SOME VIEWS ON CODE FOR DUCTILE DETAILING FOR SEISMIC DESIGN OF R.C. STRUCTURES (IS : 13920 - 1993)

SUDHIR K. JAIN & C.V.R. MURTHY
Department of Civil Engineering
Indian Institute of Technology Kanpur, Kanpur - 208 016.

The paper reviews the code IS: 13920-1993 on ductile detailing of reinforced concrete structures subjected to seismic forces. The basic philosophy behind the codal provisions is highlighted. Weaknesses and shortcomings of the code, which need to be addressed in the next edition, are discussed. Also, typographical and editorial corrections are listed.

Fig. 5: Strong column - weak girder philosophy.

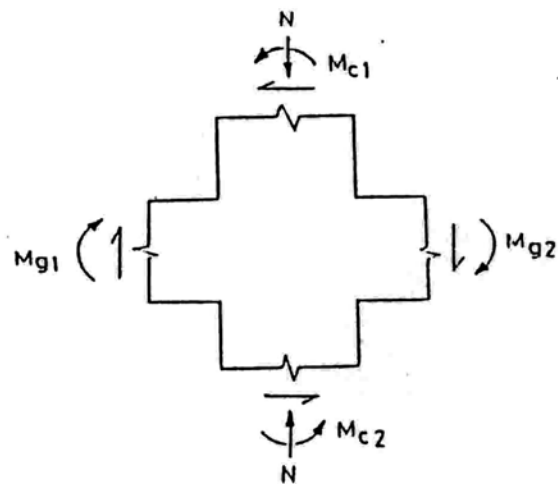
A major weakness of the code is the absence of the "strong column -weak girder" clause (Figure 5). This clause requires that the columns should have adequate flexural strength with the objective to force hinging in the beams while the columns are still elastic. This usually requires increase in the column size over what one would get in the absence of this clause. In a building with fairly uniform frame, the interior columns tend to have large axial load and negligible gravity moments; this results in most such columns being "overreinforced", i.e., the failure occurs due to crushing of concrete. Most codes do not

specifically require that the columns be designed to lie in the tension failure region of interaction diagram; however, the increased size caused by the "strong column - weak girder" clause perhaps takes care of this problem in most situations. In fact, this clause was included in the original proposal for the code (e.g., Medhekar, Jain, and Arya, 1992). It was dropped at later stages of code development. However, there is a clear need for this clause and it should be included in the next revision of the code.

Fig. 6: Anchorage of beam bars in an external joint (Figure from IS: 13920-1993).

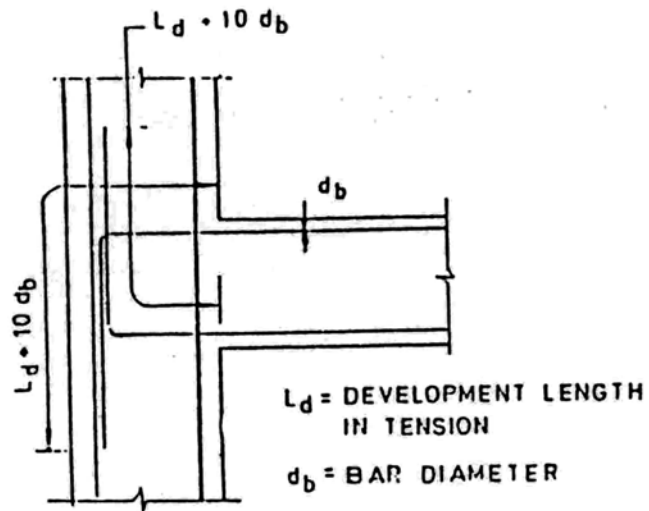
The code provides that the beam bars be properly anchored in the joint as per Figure 6 which is not sufficient. If the beam bars are of large diameter and the column width is small, this will cause the crushing of compression strut formed by the joint concrete, which is a brittle failure. Hence, we need provisions such as those given in the ACI 318 (Figure 7).
